Model	RDH for F40	Volt/Hz	Date of Modification	Serial Number
Modified Article	Parts Catalog			
Reason for Modification	Parts catalog correction

Please correct your parts catalog as follows:

Model	RDH for F40	Volt/Hz	Date of Modification	Serial Number
Modified Article	Separation belt and transport belt			
Reason for Modification	As per field request

Page 12

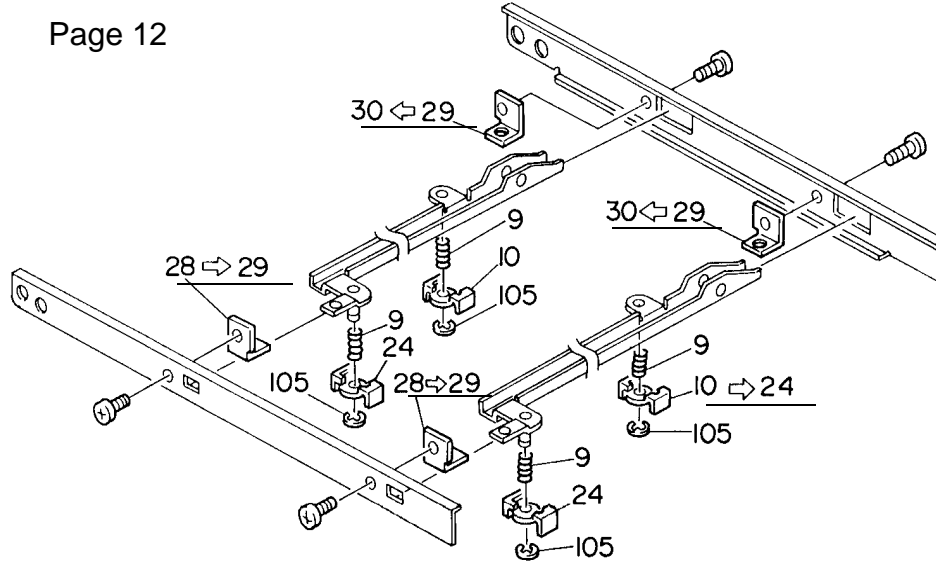
(2) Index no. change in illustration

Index No.	28 → 29
	29 → 30
	10 → 24

Page 16

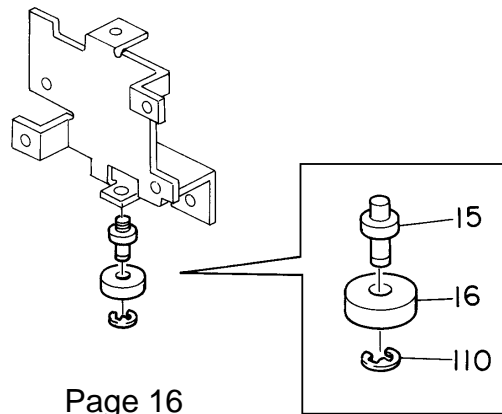
(2)

P/N	Description	Q'ty	Index No.
Incorrect	58861728	Collar - 6.1mm	1	15
	AA143286	Stepped Screw - M4	1	16
Correct	AA143282	Stud - M4	1	15
	A4992183	Locking Roller	1	16
	07200030E	Retaining Ring - M3	1	110

Page 20

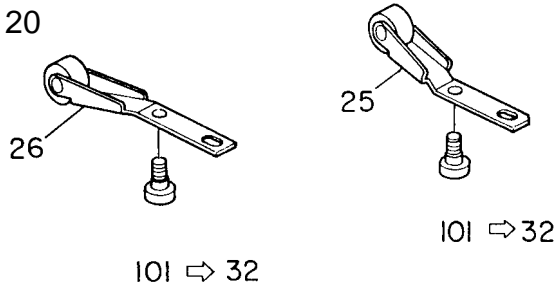
4. Page 19 Correction

P/N	Description	Q'ty	Index No.
Incorrect	03140060W	Philips Pan Head Screw - M4 x 6	8	101
Correct	AA140358	Stepped Screw - M4 x 6	8	32

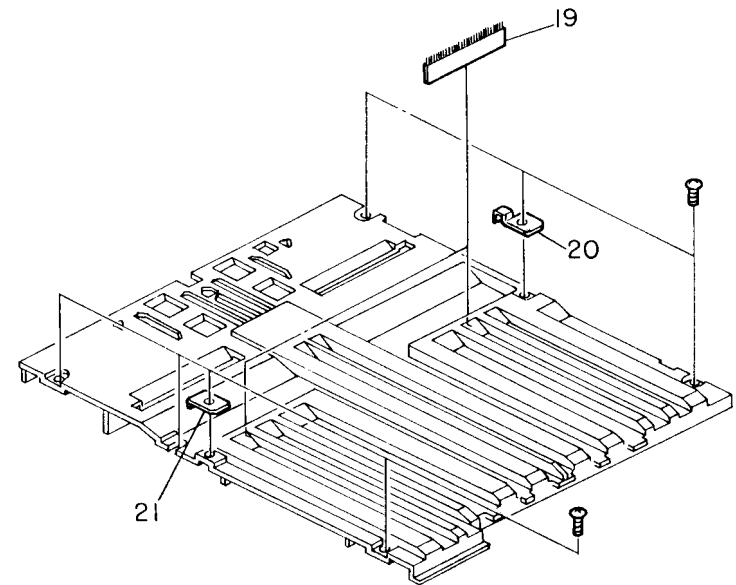
5. Page 21 Addition and deletion

P/N	Description	Q'ty	Index No.
AA120045	Antistatic Brush	2	19
A4991278	Front Grounding Plate	1	21
A4991279	Rear Grounding Plate	1	20

P/N	Description	Q'ty	Index No.
54432712	Cork Pad	1	15

Page 22

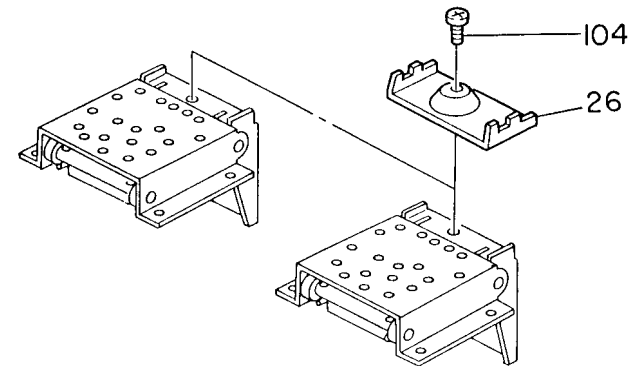
6. Page 23 Correction and Addition
(1) Correction

P/N	Description	Q'ty	Index No.
Incorrect	A4993131	Main Hinge	1	11
	A4971152	Magnet - APS	1	24
Correct	A4993171	Left Hinge	1	11
	A4993632	Magnet - APS	1	24

P/N	Description	Q'ty	Index No.
A4994125	Hinge Stopper	2	*26

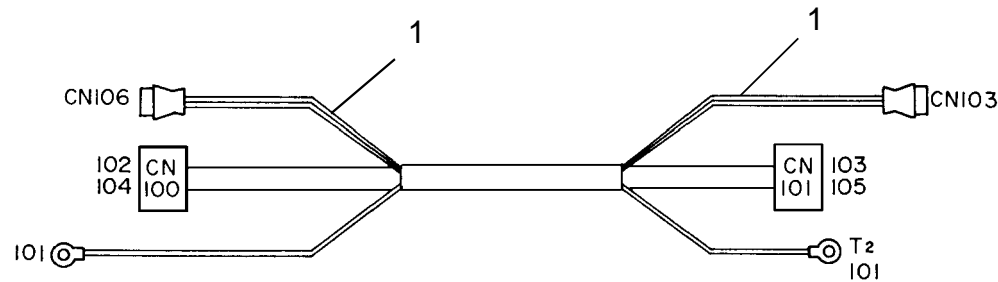
6. Page 30 Addition

Index No. add to the illustration

Page 15

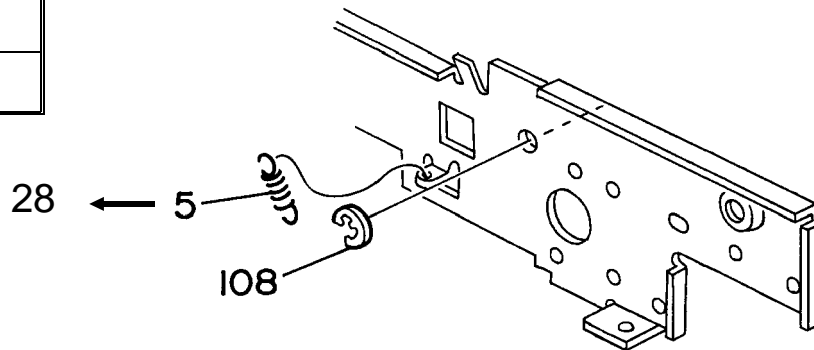
2. Index No. Correction in illustration

Index No.	5 → 28
	25 → 27

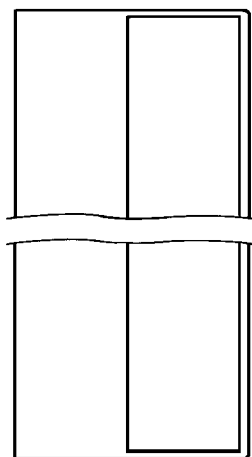
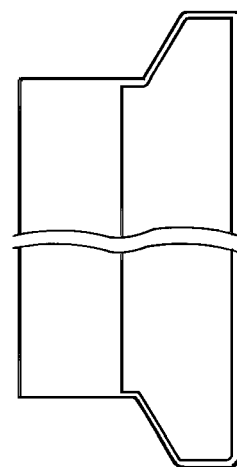
Model	RDH for F40	Volt/Hz	Date of Modification	Serial Number
Modified Article	Original Guide Mylar			
Reason for Modification	To prevent jams caused by curled originals

To ensure that curled originals pass through the original exit, the original guide mylar has been redesigned.

Old P/N	New P/N	Description	Q'ty	Interchangeability	Index No.	Page
A4972024		Paper Guide Mylar	1	X/	8	11
	A4991712	Original Guide Mylar	1	/O	8	11

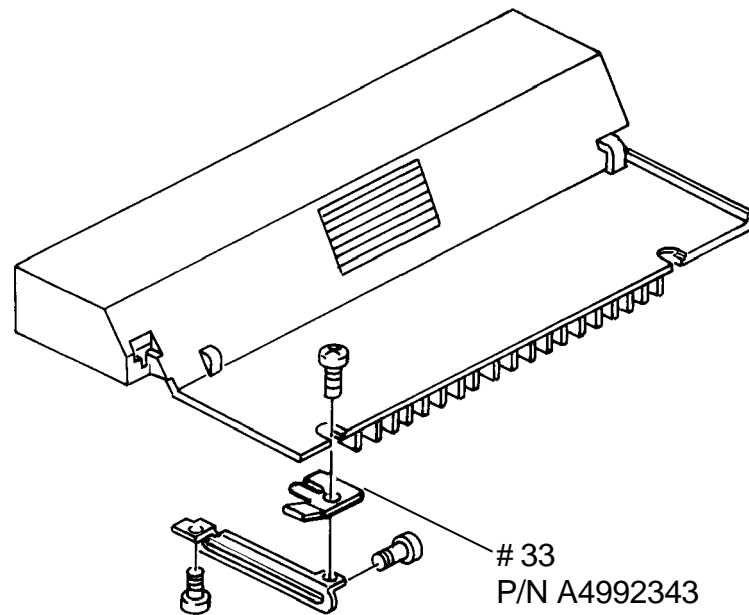
1. Grounding Plate P/N A4992343
To prevent electrical noise caused by static electricity, the grounding plate has been added as shown below.

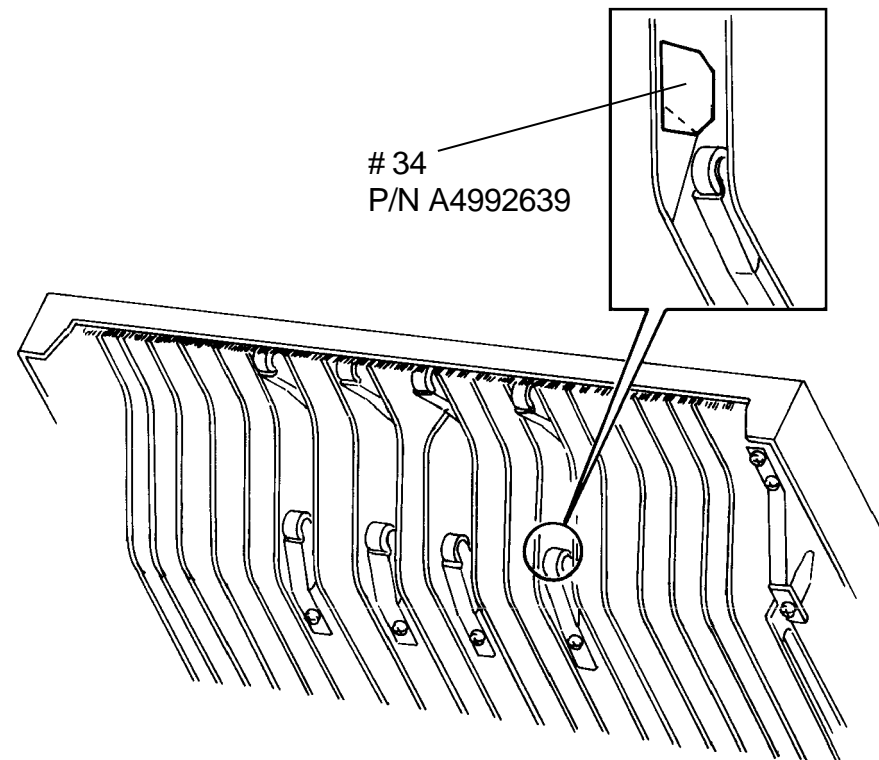
2. Exit Sensor Seal P/N A4992639
To improve the sensitivity of the exit sensor (photosensor) a black seal (Exit Sensor Seal) has been placed on the cover.

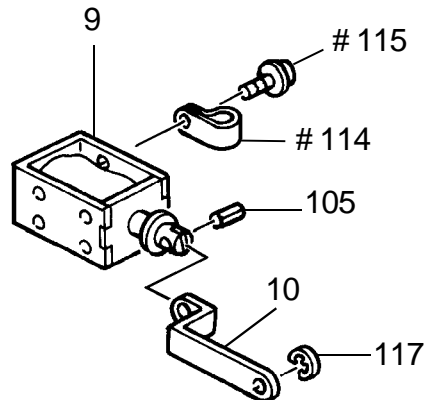
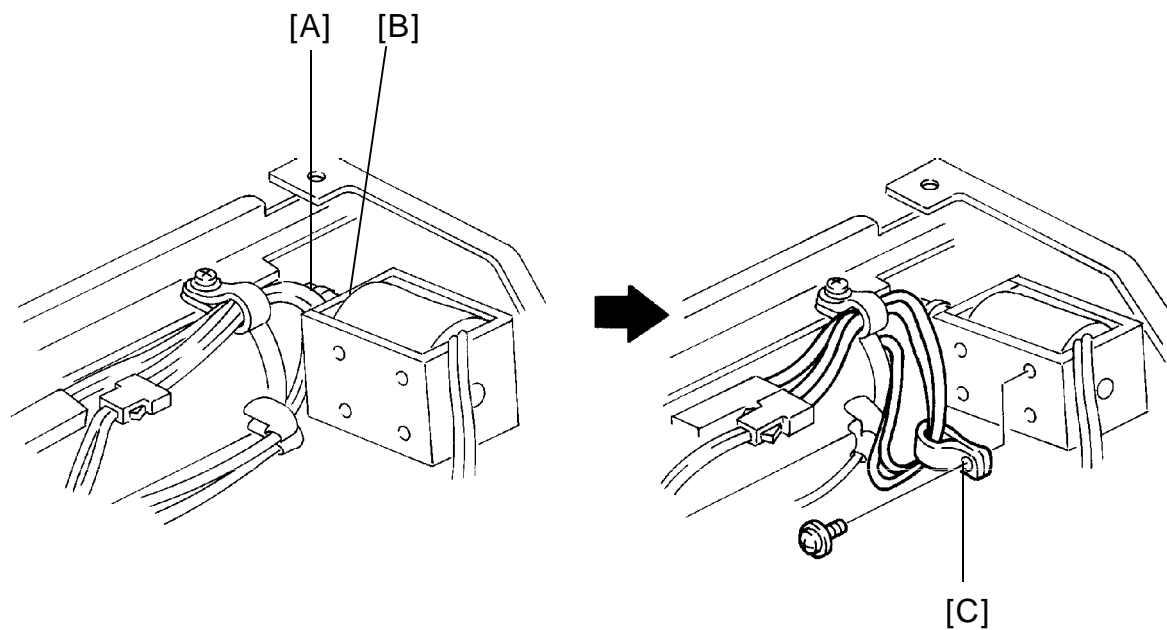
1) There is a possibility that the paper feed motor harness (yellow) [A] is caught in the original stopper solenoid plunger [B]. To avoid that possibility, the Nylon Clip-2N [C] is added on the solenoid to hold the harness.

New P/N	Description	Q'ty Used Old → New	Parts Catalog	
			Index No.	Page
11050008	Nylon Clip - 2N	0 → 1	# 114	9
09513005W	Philips Screw With Flat Washer - M3 x 5	0 → 1	# 115	9

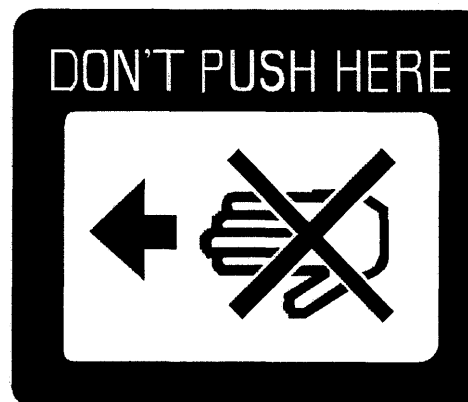
SAVIN has pointed a potential problem:

If the operator uses the sliding cover to move the original feed-out unit, he or she may inadvertently derail the cover.

To guard against this , this decal is added:

New Part Number	Description	Index Number	Page
A4996101	Decal - Cover - Slide	35	20-

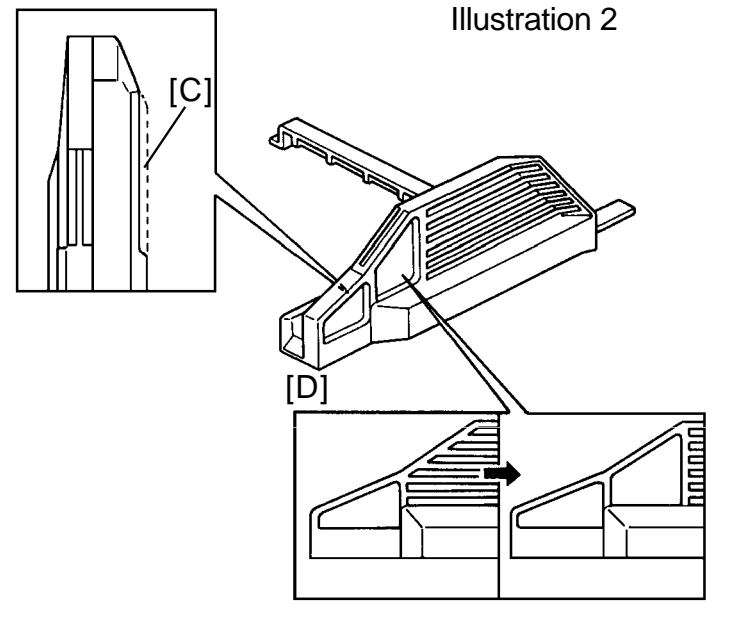
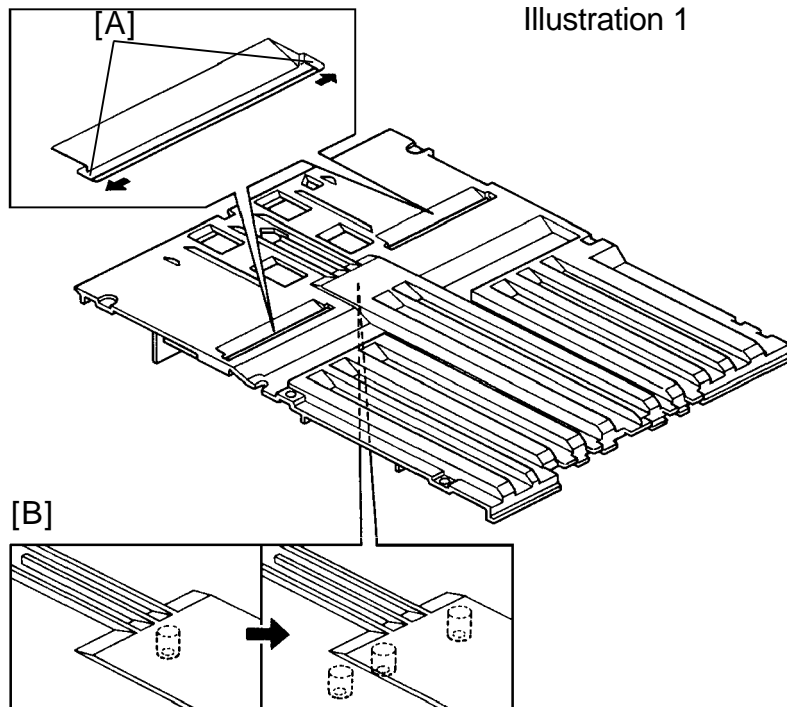
Following five items are modified to enable original side to side registration adjustment.

1. Original Table - Paper Feed

- Side fence rail cut outs [A] have been enlarged.
- Screw holes [B] have been added and moved.

2. Front Side Fence

- Part of the side fence paper rail [C] has been removed.
- A part of the front side fence [D] has been made thinner.

Illustration 3

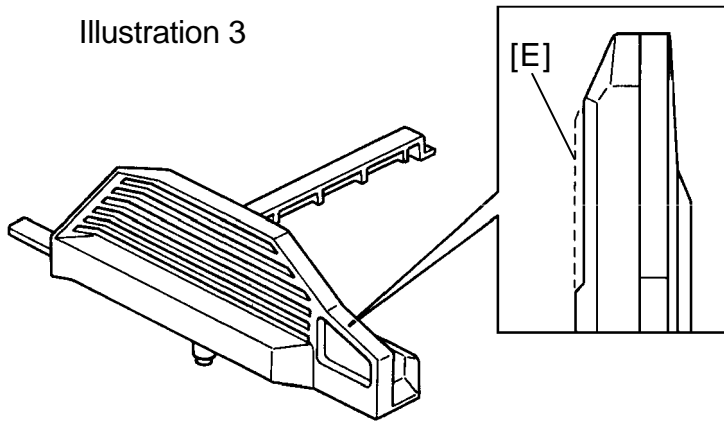
3. Rear Side Fence

- Part of the side fence paper rail [E] has been removed.

Illustration 4

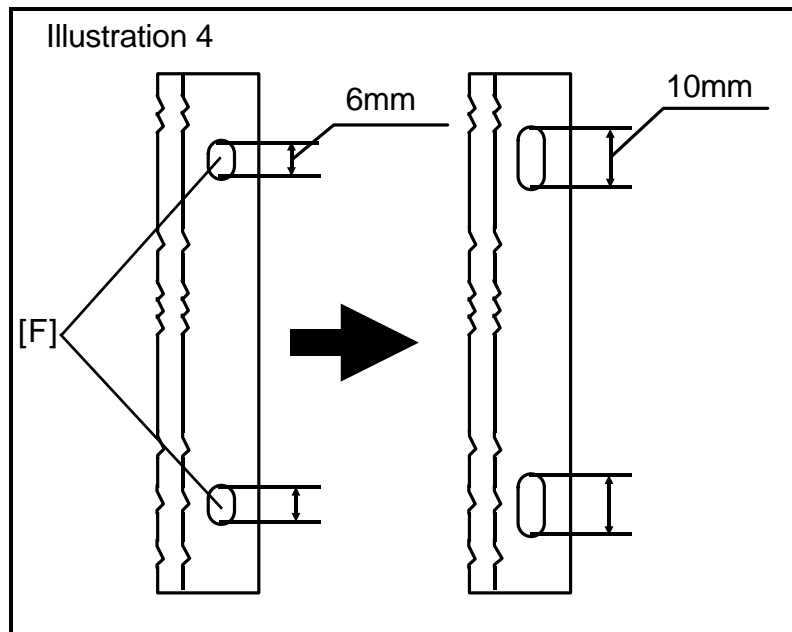
4. Side Fence Guide Rail

- Two holes [F] on the side fence guide rail have been enlarged.

5. Side Fence Guide Bracket

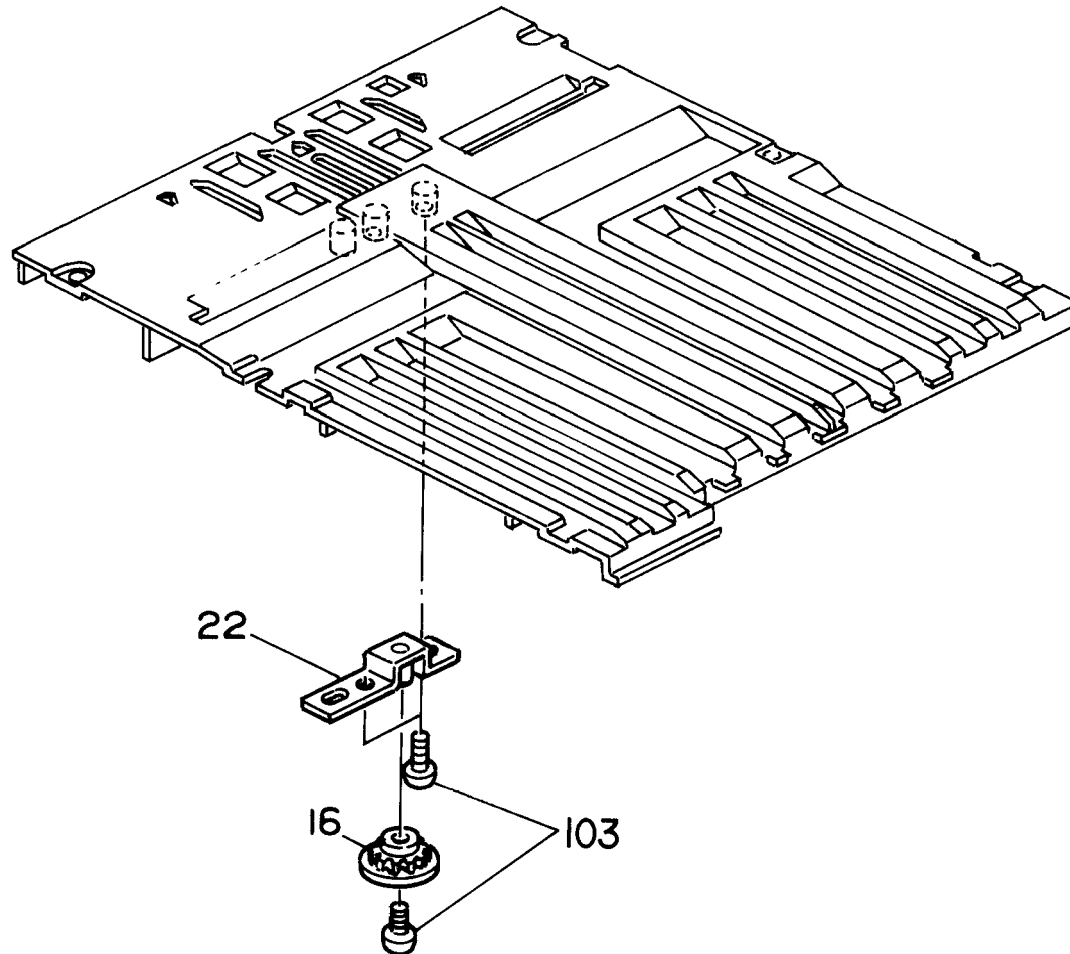
- The part (P/N A4991247, Index No. *22) is newly added.

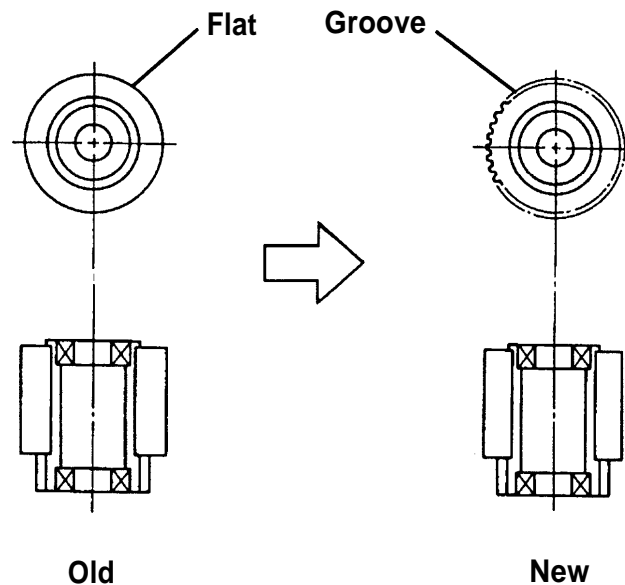
To improve feeding of the original, the groove has been added on the original feed roller.

Old P/N	New P/N	Description	Q'ty	Interchangeability	Index No.	Page
A4991211	A4991213	Original Feed Roller	1 - 1	x/O	2	7

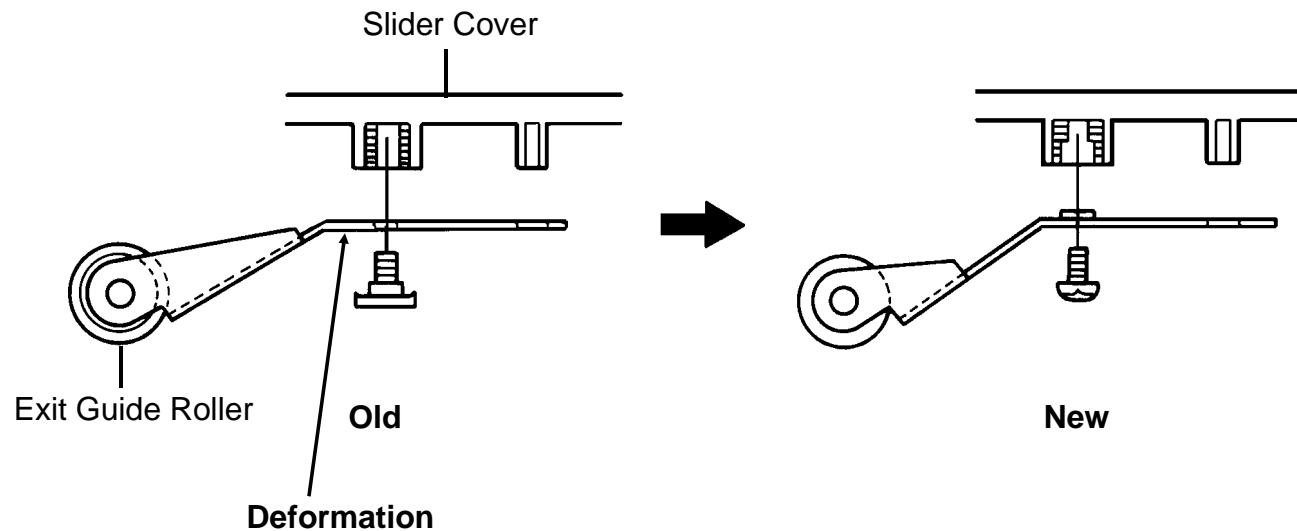
To prevent the exit guide roller from generating the noise due to the deformation of the exit guide roller bracket, the slider cover and exit guide rollers have been changed.

Model		RDH for F40					Volt/Hz	Date of Modification	Serial Number	
Modified Article		Exit Guide Roller								
Reason for Modification		To prevent noise								
Draw No.	Old Parts No.	New Parts No.	Description	A.B.C.	Q'ty Used Old → New	Inter-changeability	Part needed for replacement by new part		Parts Catalog	
				Rank			Part No.	Description	Index No.	Page
	A4992301	A4992306	Slider Cover (Ricoh)		1 → 1	X / X			2	19
	A4992302	A4992307	Slider Cover (P.B)		1 → 1	X / X			2	19
	A4992303	A4992308	Slider Cover (SAVIN)		1 → 1	X / X			2	19
	A4992304	A4992309	Slider Cover (NRG)		1 → 1	X / X			2	19
	A4992305	A4992310	Slider Cover (infotec)		1 → 1	X / X		X / O as a set	2	19
	A4992326	A4992328	Exit Guide Roller - Left		4 → 4	X / X			26	19
	A4992321	A4992323	Exit Guide Roller -Right		4 → 4	X / X			25	19
	AA140358		Stepped Screw - M4X6		8 → 0	X / X			32	19
		03140060W	Philips Pan Head Screw - M4X6		0 → 8	X / X			101	19

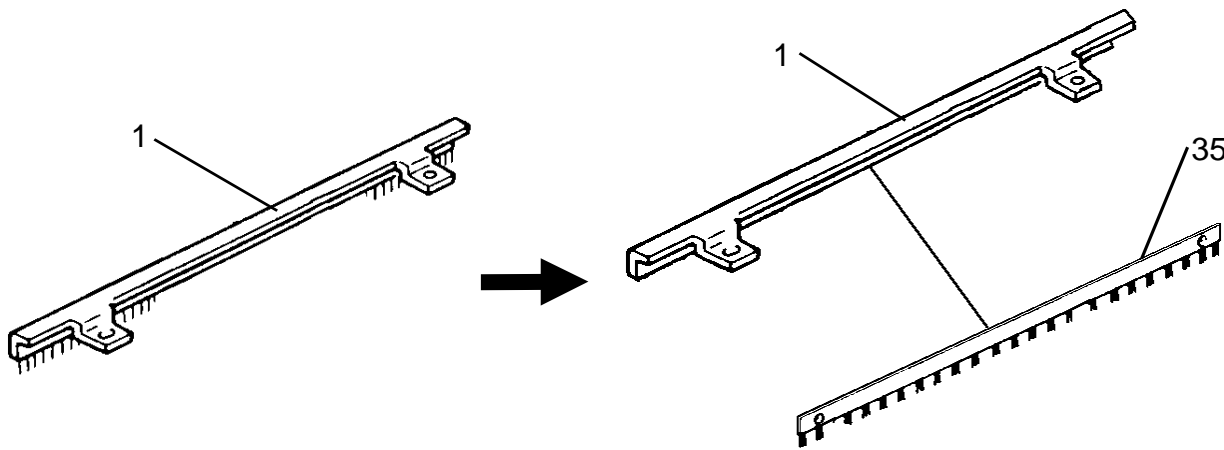
New P/N	Description	Q'ty Used	Parts Catalog	
				Index No.	Page
Incorrect	A4992338	Antistatic Brush Plate	1	1	19
Correct	A4992338	Antistatic Brush Plate	1	1	19
	AA120032	Antistatic Brush	1	* 35	19
